FIELD SERVICE BULLETIN

SERVICE DEPARTMENT
CONSOLIDATED VULTEE AIRCRAFT CORPORATION
San Diego, California, U.S.A.

October 15, 1944

Figure 14. Cutaway View of Bombardier's Window.

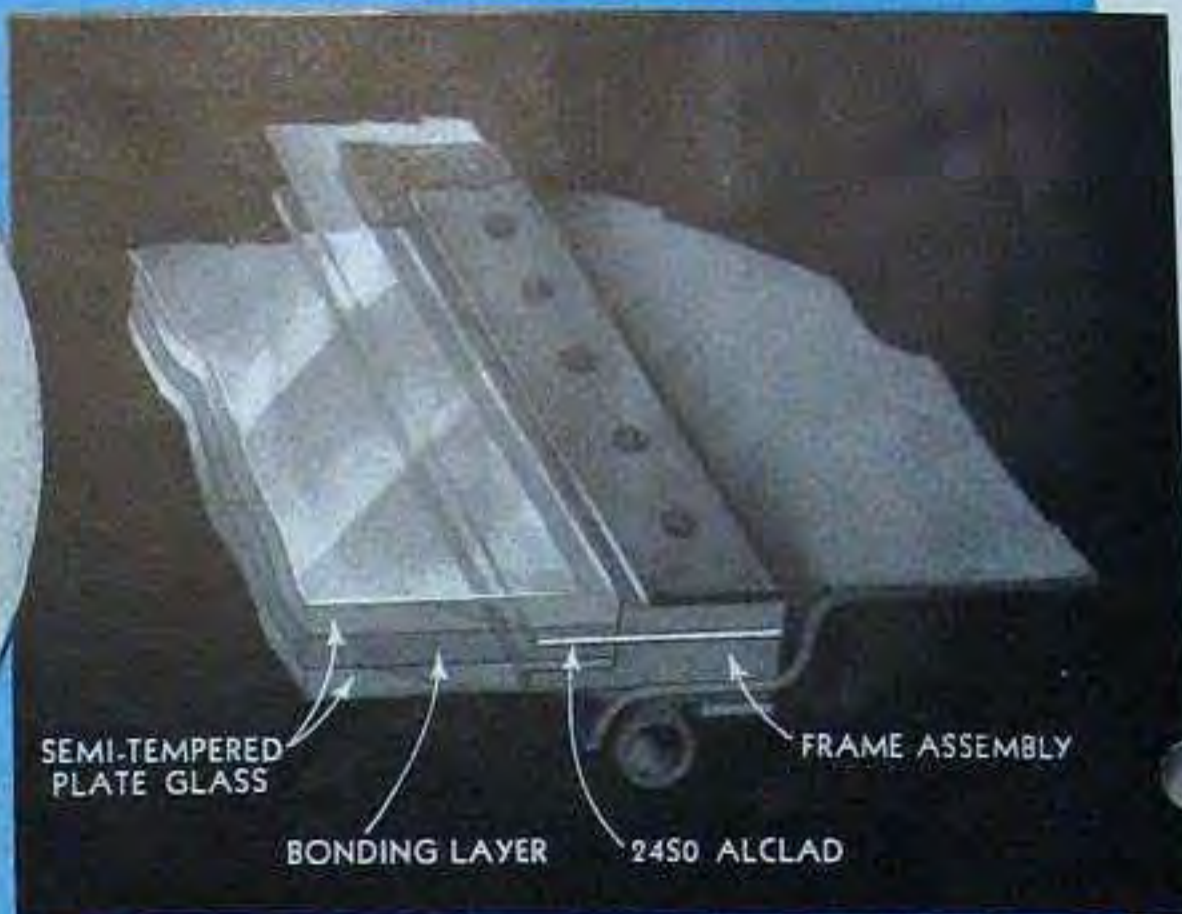
A plane, four-sided window with two parallel sides (figure 13) replaces the former rectangular window. Installation of this trapezoidal-type window and backing door necessitated removal of the sliding shutter and accompanying mechanism, and the rectangular window and backing door.

The new glass (figure 14) is of three-ply laminated construction; the two outer plies are semi-tempered plate glass, 3/16" thick; the inner ply, or bonding layer, is Vinyl plastic, 3/16" thick. The frame construction of the glass is of Vinyl plastic, reinforced with a strip of 2450 alclad which extends back into the
